Memo

| Subject: | Merrimu PSP Landscape & Visual Character Assessment Peer Review Report | | |

Following a request from Ethos Urban on behalf of Bacchus Marsh Developments Pty Ltd, Hansen Partnership has undertaken a peer review of the *Merrimu PSP Landscape & Visual Character Assessment, October 2023 (LVCA)* prepared for the Victorian Planning Authority (VPA) by Tract Consultants.

Figure 1

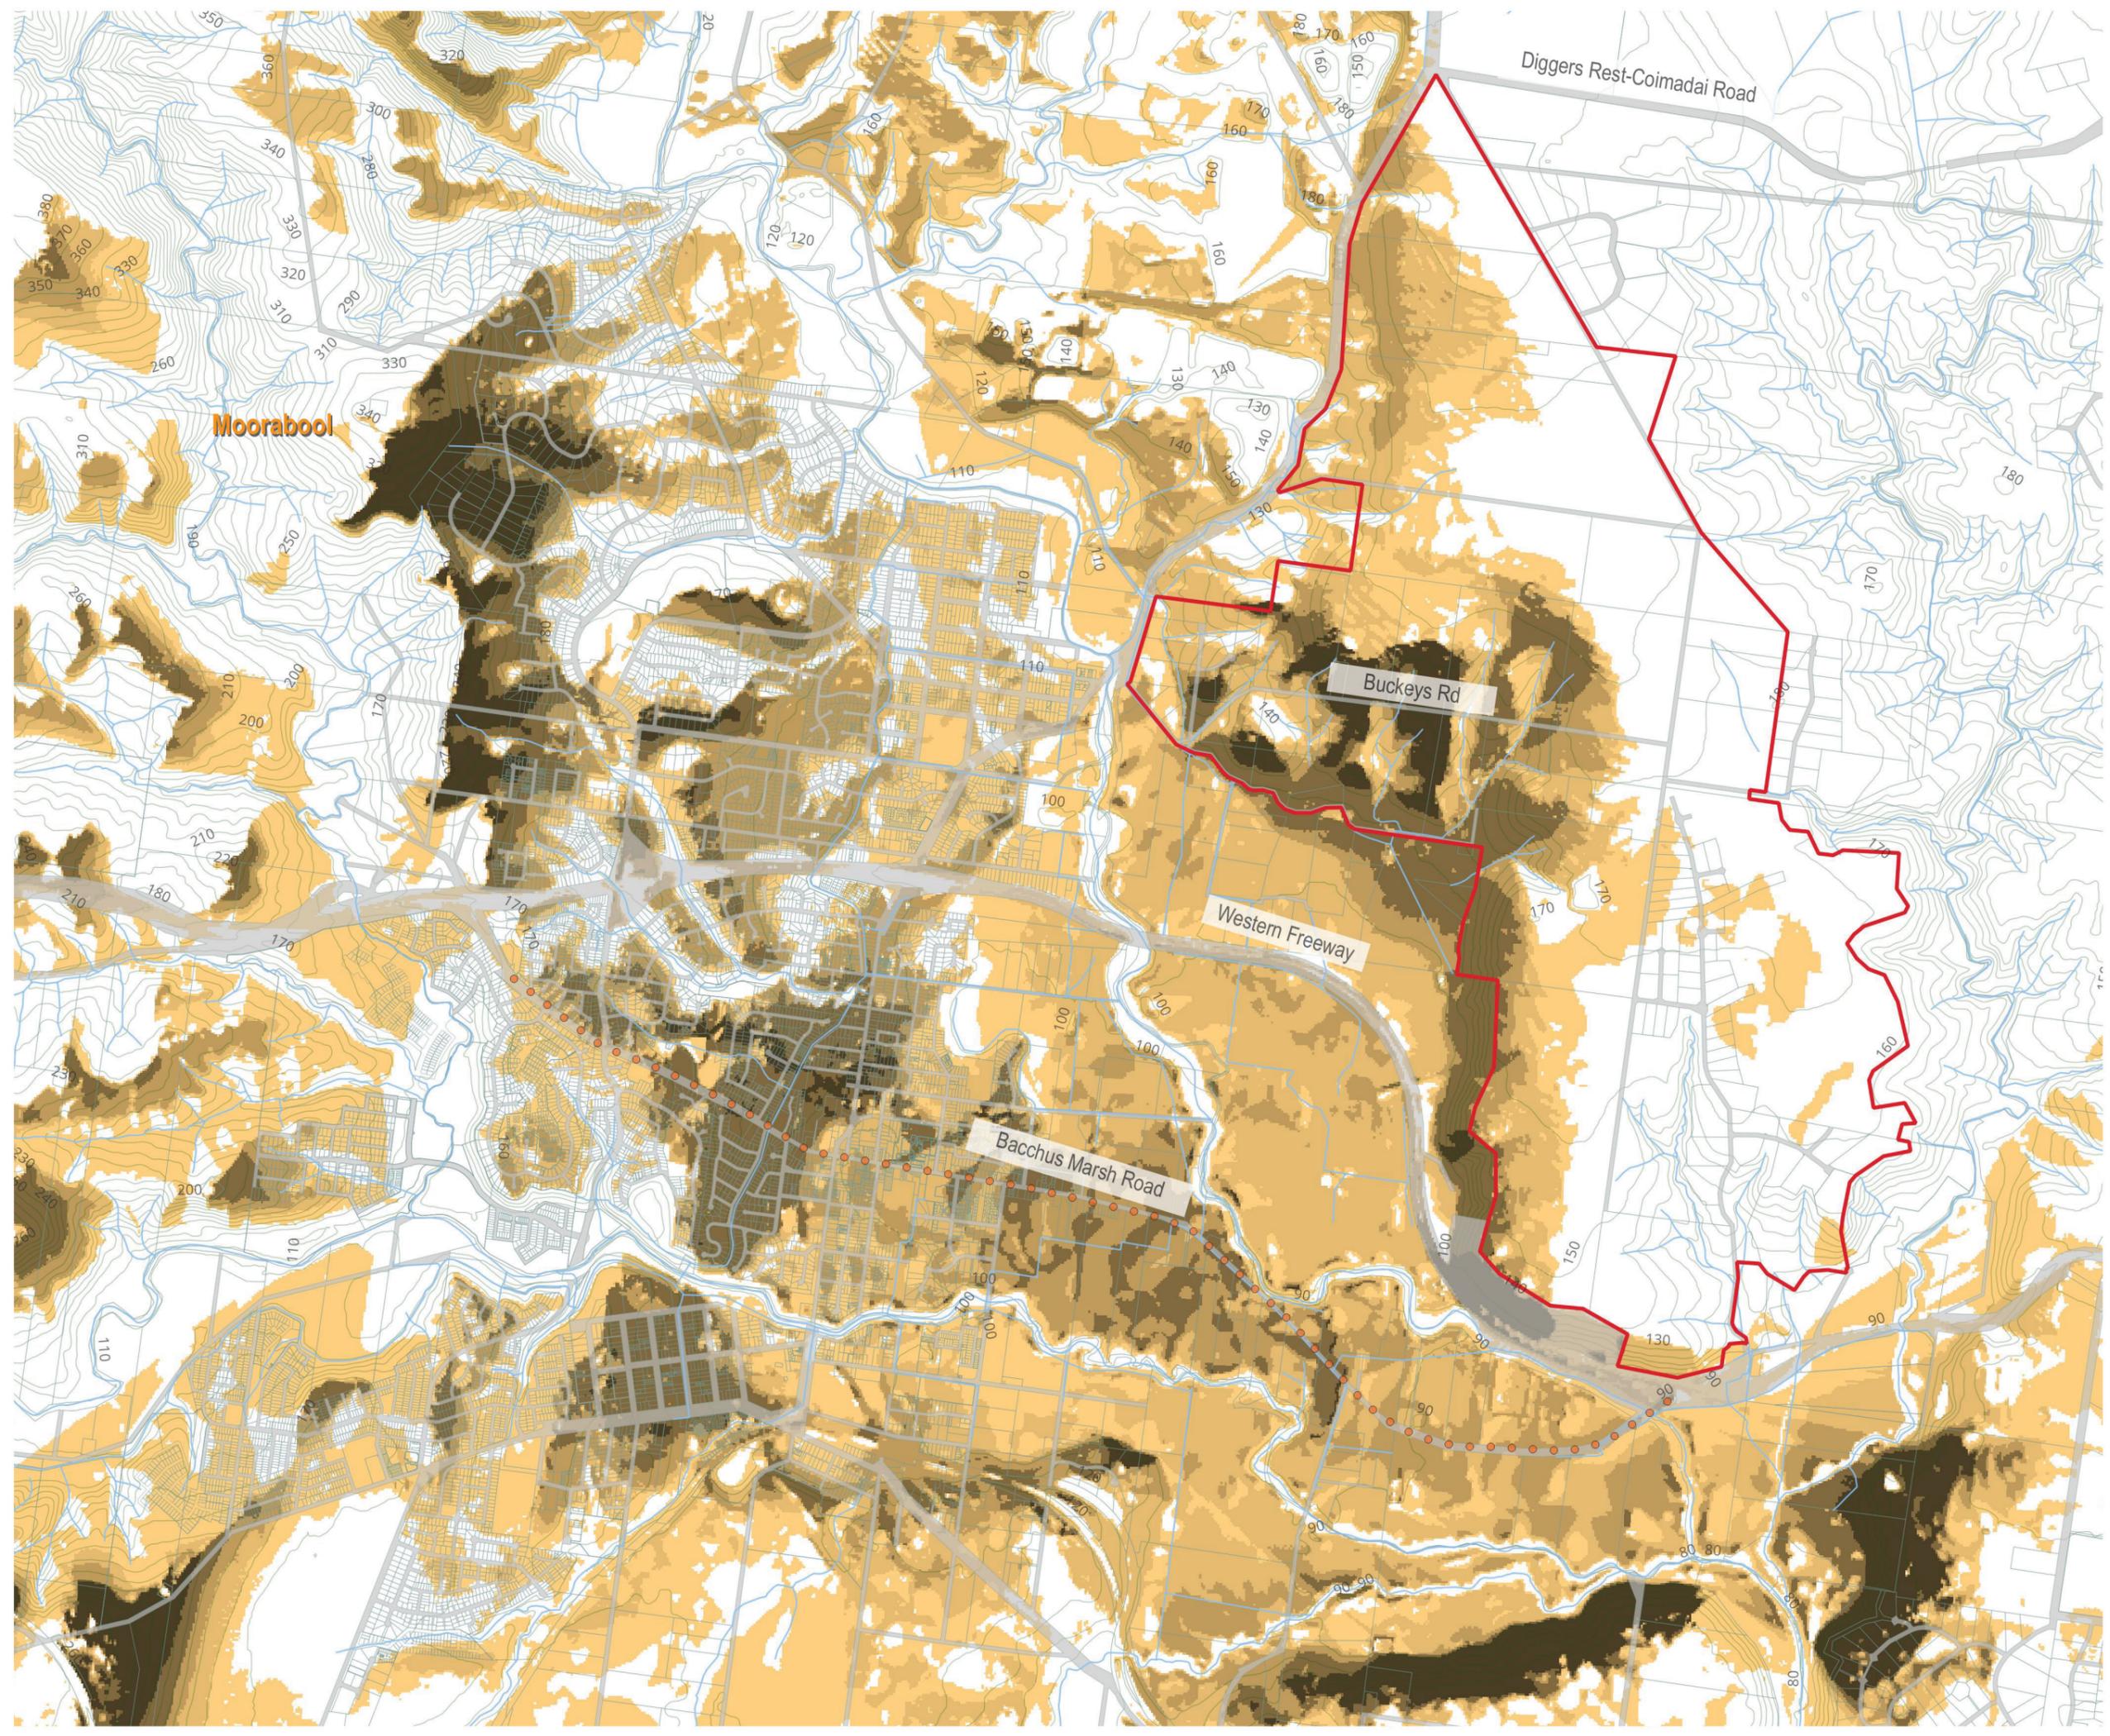
The number of viewpoints used to generate the ZVI however is considered somewhat deficient, on the basis that the ZVI maps at Figures 19 and 20, which illustrate the extent of theoretically visible land from the key transport routes of the Avenue of Honour and the Western Freeway, have been prepared using a very small number of viewpoints; 3 for the Avenue of Honour and 4 for the Western Freeway, at approximately 2 kilometre intervals.

By relying on such a small number of viewpoints, two deficiencies occur:

- Firstly, there is the potential to miss potential vantage points between those selected, which might offer vistas of parts of the Merrimu PSP area not able to be seen from the selected points, and
- There is little or no opportunity to develop an appreciation of the relative levels of visual exposure of different parts of the Merrimu PSP area.

To demonstrate this deficiency, we have independently undertaken ZVI modelling along the same key transport routes, but utilising viewpoints at 100 metre intervals. The resultant mapping, at Figures 1 and 2 below, demonstrates a much more nuanced analysis of the relative visual exposure of surrounding land to viewpoints along the key transport routes. It allows a categorisation of visual exposure from high level, where land is visible from at least 80% of identified viewpoints along each of the key transport routes, to low level where land is visible from less than 20% of identified viewpoints along each of the key transport routes.

The value of such an outcome is that it allows the opportunity to determine a defensible rationale for the application of 'visual management', for example applying such measures to land identified as having moderate or higher visual exposure but excluding land identified as having lower levels of visual exposure.

Figure 3

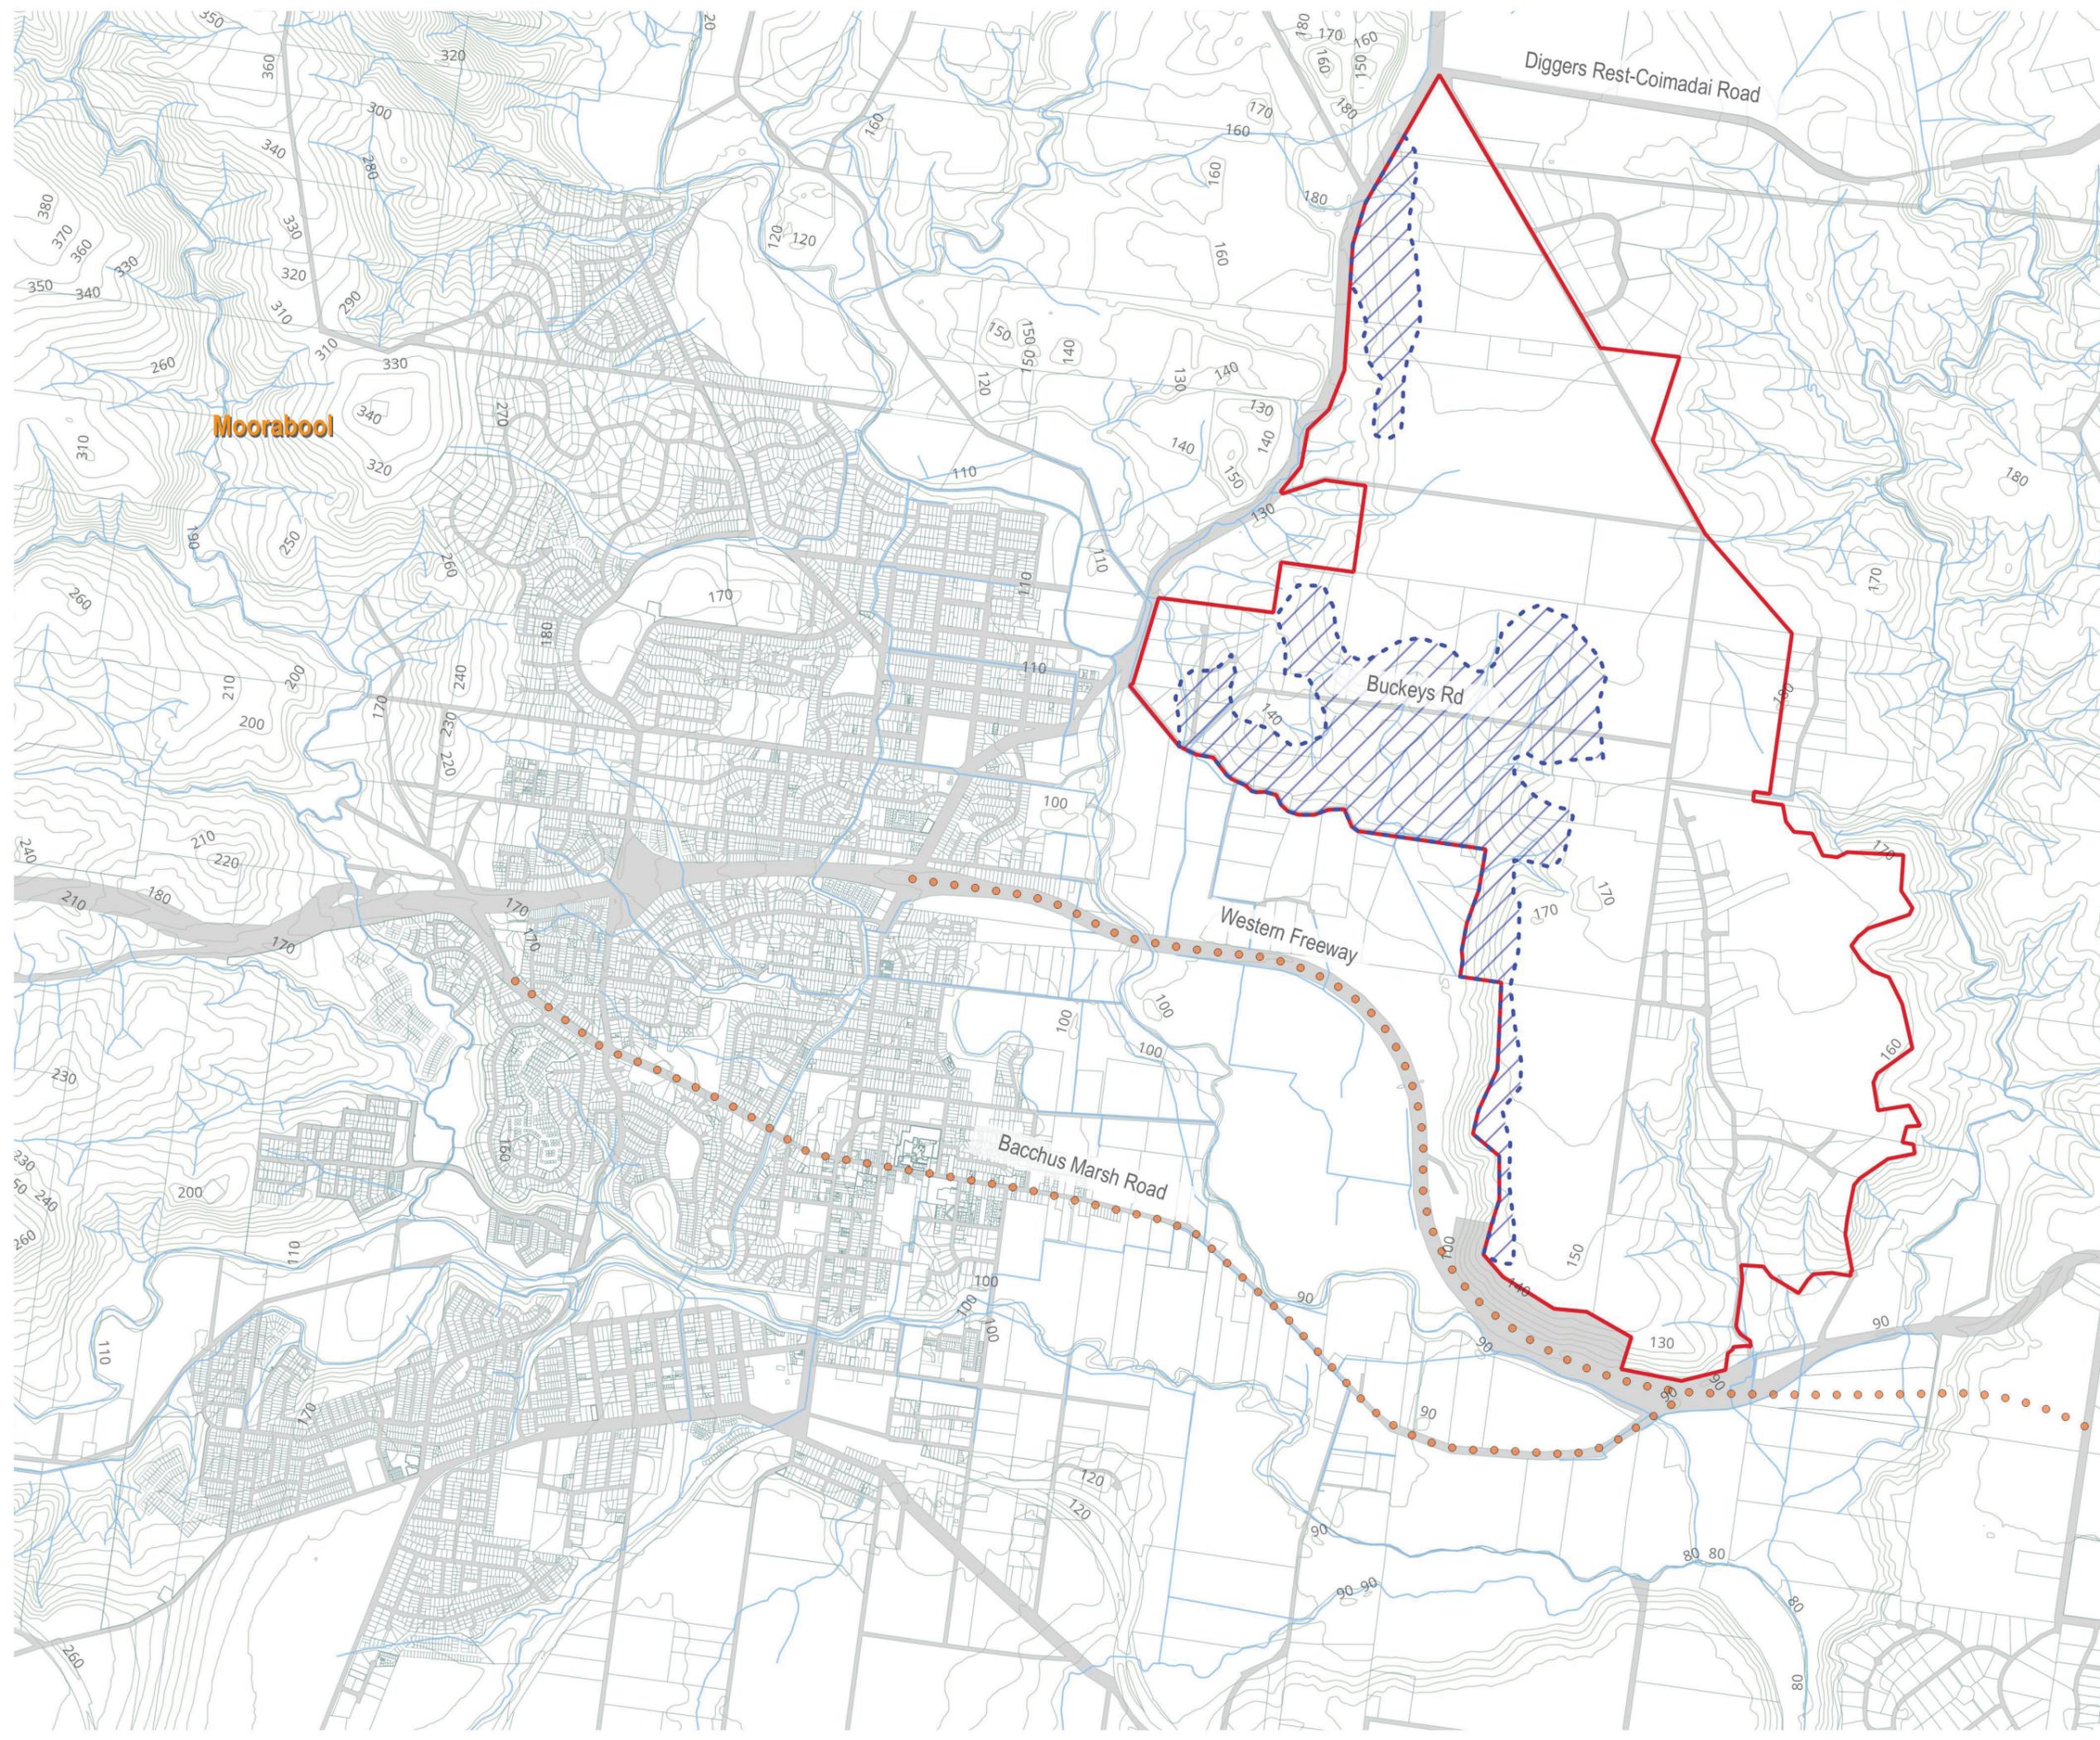
Consistent with the observations above, one of the key recommendations of the LVCA – the identification of areas requiring ‘visually managed development’ to “preserve the visual integrity of regional views into the precinct” – is deficient in that it has been determined on the basis of a limited dataset, ie a total of only 7 viewpoints at approximately 2 kilometre intervals along the key transport routes of the Avenue of Honour and the Western Freeway.

As a result, the area identified in Figure 21 within the LVCA as being recommended for “visually managed built form” offers no discretion with respect to either the relative level of visual exposure of land within the PSP area nor is it informed in any obvious manner by the differing levels of scenic quality of landscapes identified in Section 4.3 of that report. In effect the recommendation applies to all land within the PSP area which falls within the theoretical viewshed of 7 viewpoints, regardless of its degree of visual exposure or its level of scenic quality.

For comparison, we have mapped the extent of land within the Merrimu PSP area which has been assessed through our own ZVI modelling - using a significantly greater number of viewpoints – as having moderate or higher visual exposure to the key transport routes. Specifically, this comprises land which is theoretically visible from at least 40% of modelled viewpoints along each of the key transport routes. The extent of land identified occupies a significantly-reduced extent of land within the Merrimu PSP area than that identified in Figure 21 of the LVCA. Our mapping is shown at Figure 3 below.
